# T ECHNICAL INFORMATION

75599  
March 2006

- Subject** ▶ Change of Retaining Ring (EXT) S-18 and Guide Sleeve
- For Models** ▶ BJR181, JR3050T, JR3060T, JR3070CT
- Country** ▶ All countries
- Description** ▶ Retaining ring (EXT) S-18 and Guide sleeve have been changed as illustrated below.

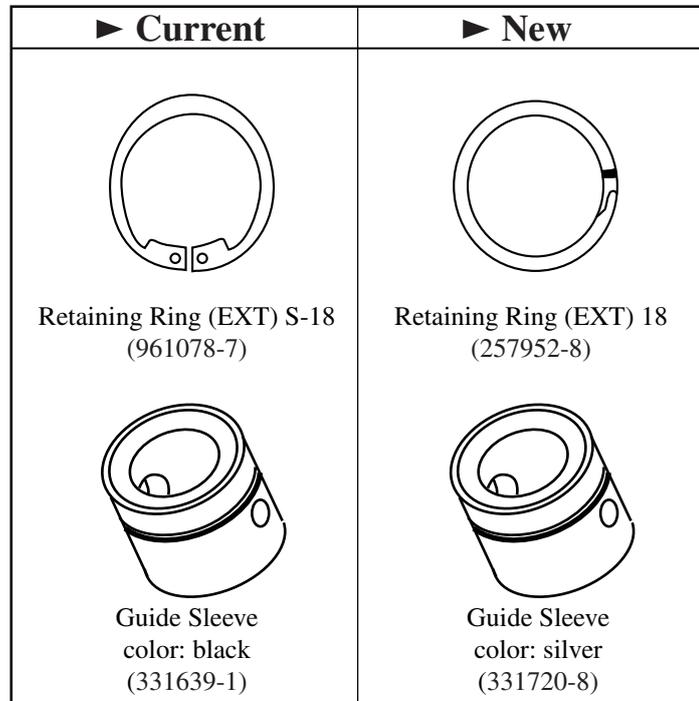
Item No.	Current part		Q'ty	I/C	New part		Q'ty	Note
004	Retaining Ring (EXT) S-18 ----- 961078-7		1	No	Retaining Ring (EXT) 18 ----- 257952-8		1	The current remains available. ↑ Interchangeable as a set ↓
BJR181, JR3050T: 009 JR3060T, JR3070CT: 007	Guide Sleeve ----- 331639-1		1	No	Guide Sleeve ----- 331720-8		1

To be implemented from April 2006 production.
